**PROPOSED SURFACE WATER SEWER
DIVERSION SCHEME REVIEW**

**PROPOSED SURFACE WATER SEWER DIVERSION SCHEME REVIEW
FOR NORTHIAM PARISH COUNCIL**

Rev.A - March 2023

Project Name The Paddocks, Northiam

Drawing Title
PARISH COUNCIL SEWER DIVERSION, PLANS AND SECTION.

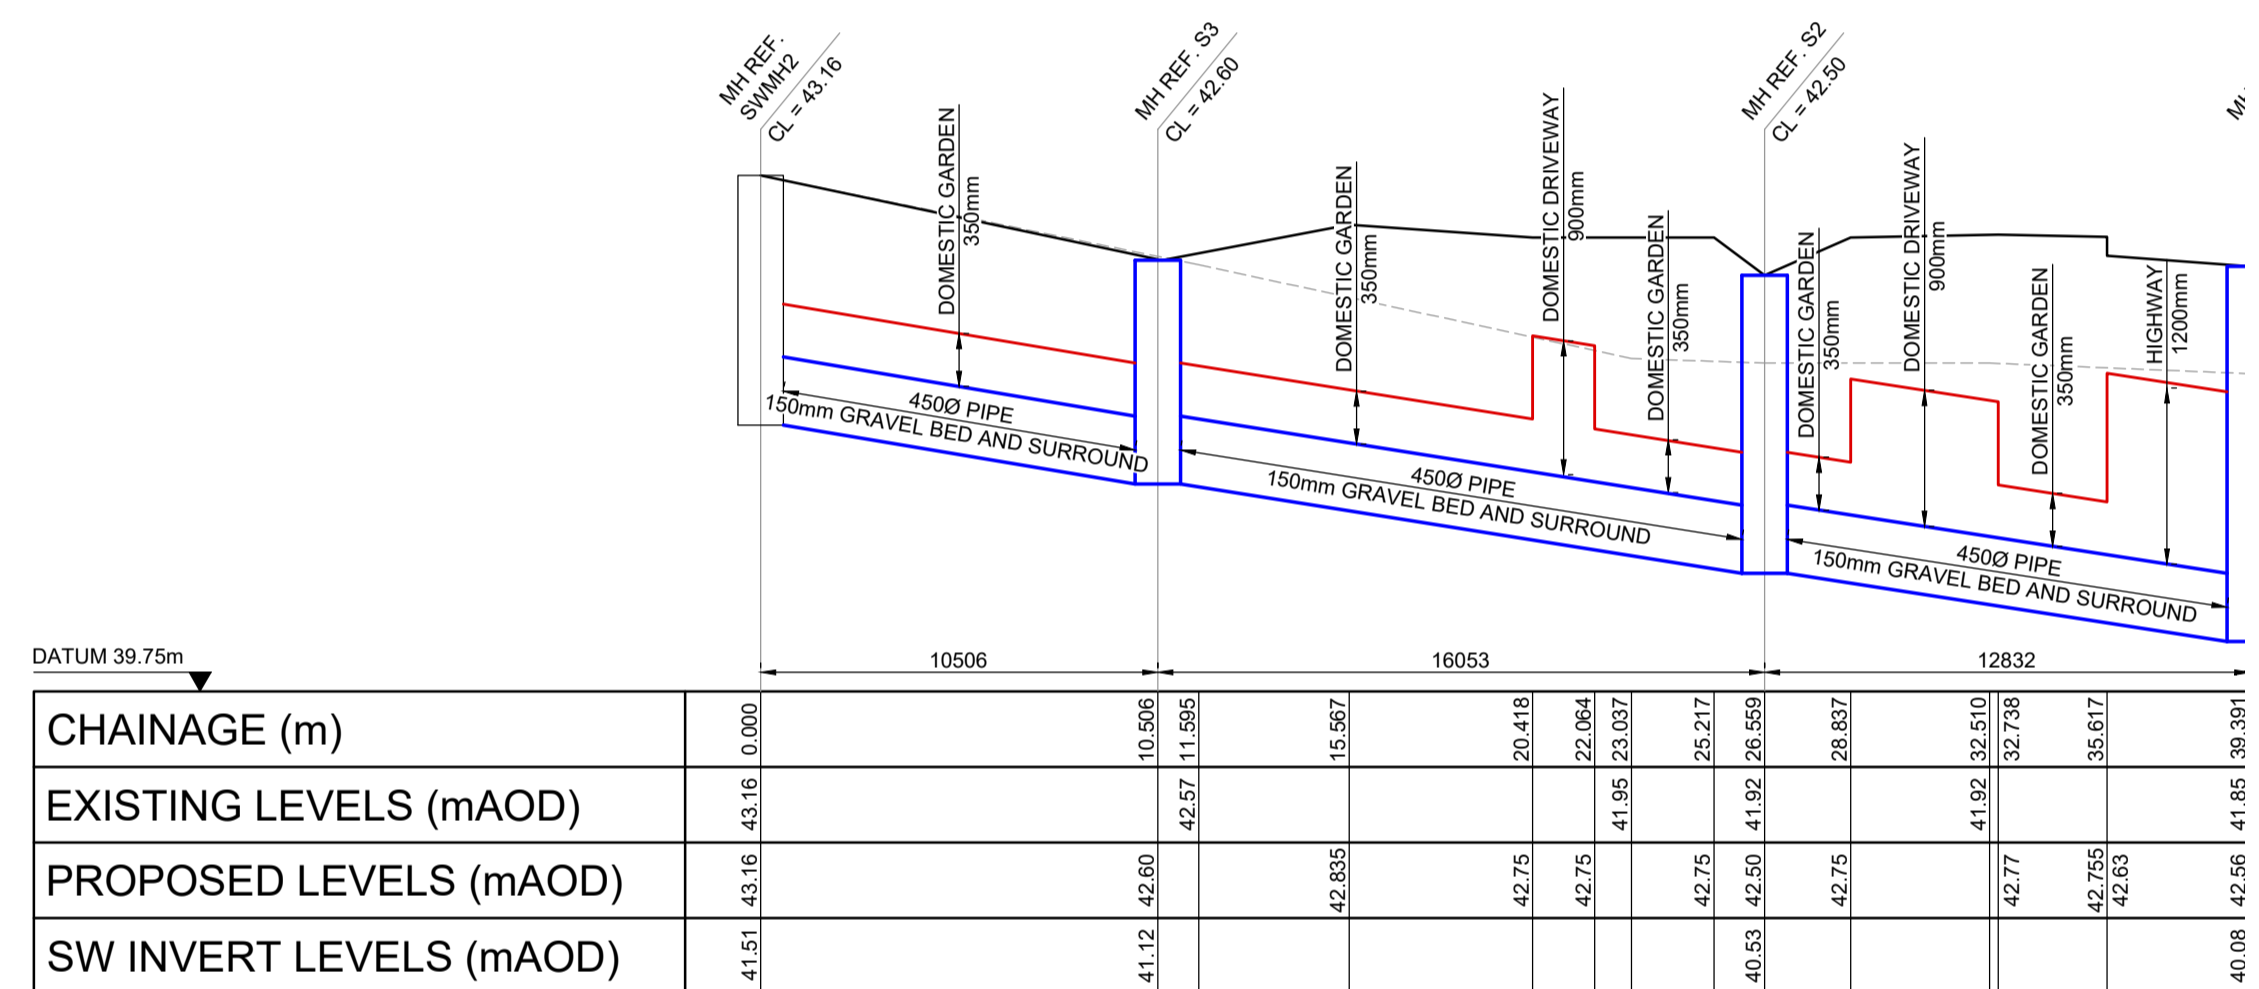
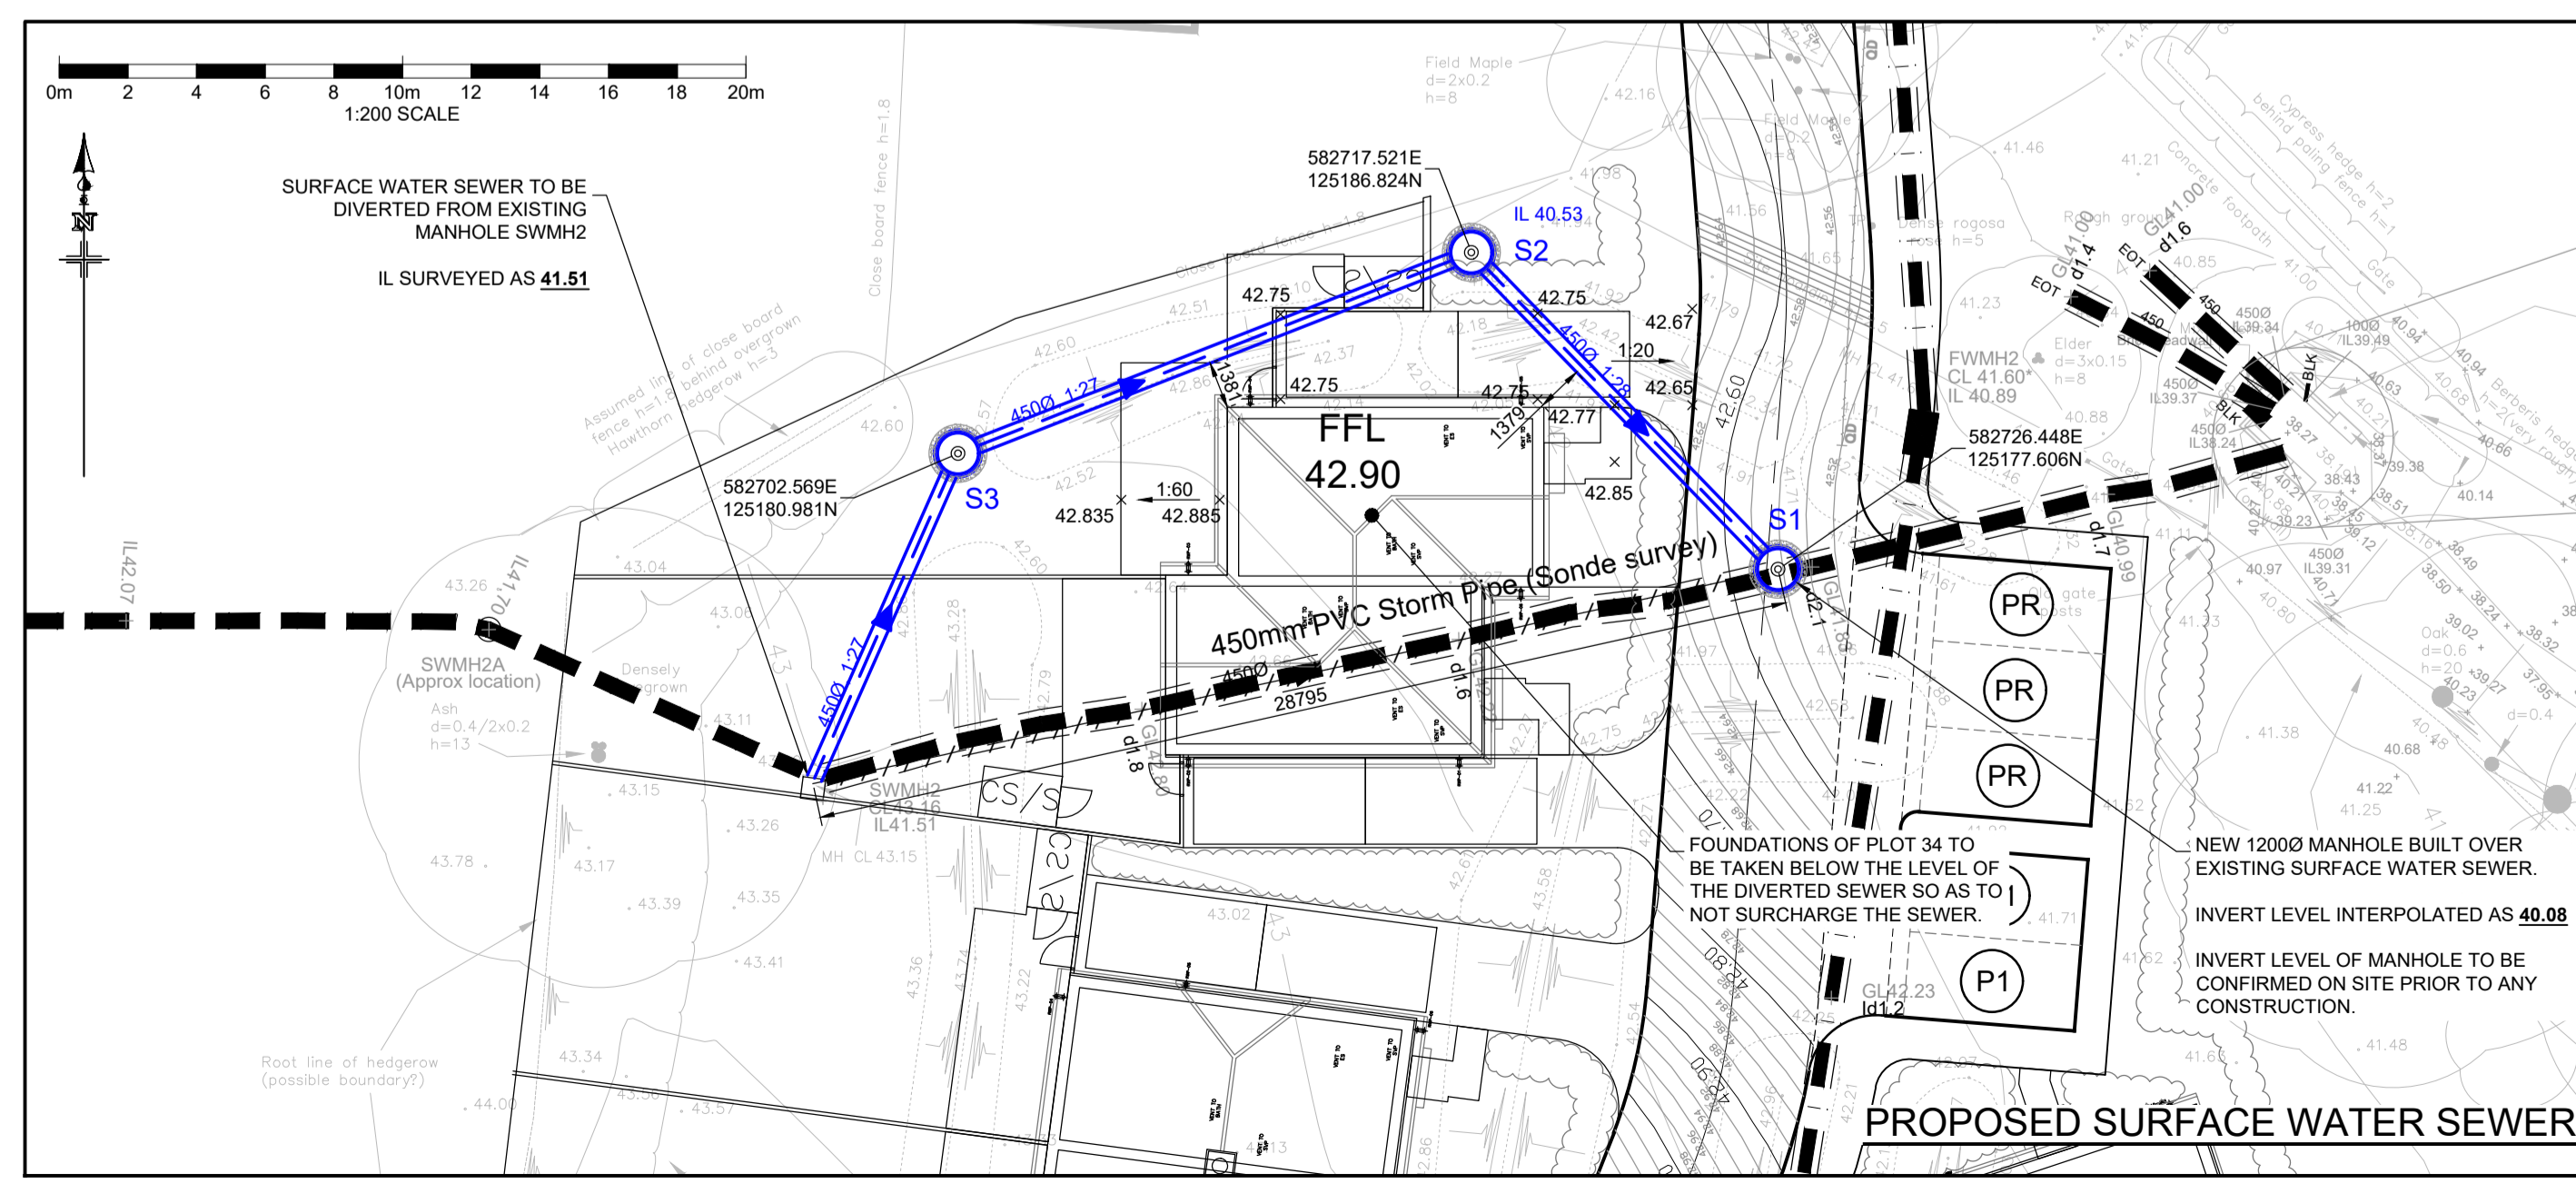
2.1.1 Based on the CCTV report and information shown on the AC22065-ABS-XX-XX-SE-C-5303, revision C01 drawing the estimated gradient of the existing sewer is 1 in 19.3.

2.2.1 The proposed diversion scheme includes re-routing part of the existing sewer along new alignment. The diversion is proposed to start at an existing manhole (referenced as SWMH2 on drawing AC22065-ABS-XX-XX-SE-C-5303, revision C01) and intercept back the existing sewer some 28.8m downstream of the existing manhole when measured along the centreline of existing sewer.

2.2.4 Based on the proposed diversion long section (shown on drawing AC22065-ABS-XX-XX-SE-C-5303, revision C01) the total length of the diversion appears to be 39.4m, with the flattest gradient being 1 in 27.

2.2.7 It appears that the proposed diversion sets the pipes at a minimum distance of approximately 1.38 m measured between the pipe (assumed to be its internal face) and the external wall of the proposed plot 34. It would be more desirable to indicate a distance between the outer edge of the proposed diverted pipe and the foundations of plot 34, and such distance ideally should be not less than 1.2 m.

2.2.8 Drawing AC22065-ABS-XX-XX-SE-C-5303, revision C01 calls for foundations of plot 34 to be taken below the levels of the diverted sewer. Such approach follows the best practice standard and is often requested by water companies when diverting or building close to the public sewer to protect the pipeline from increased loading from the building.

2.2.9 The diversion long section shown on drawing AC22065-ABS-XX-XX-SE-C-5303, revision C01 indicates that the minimum cover (depending on the land use above the pipe) will be achieved and specifies the pipe surround accordingly, all of which complies with the current best practice standard.
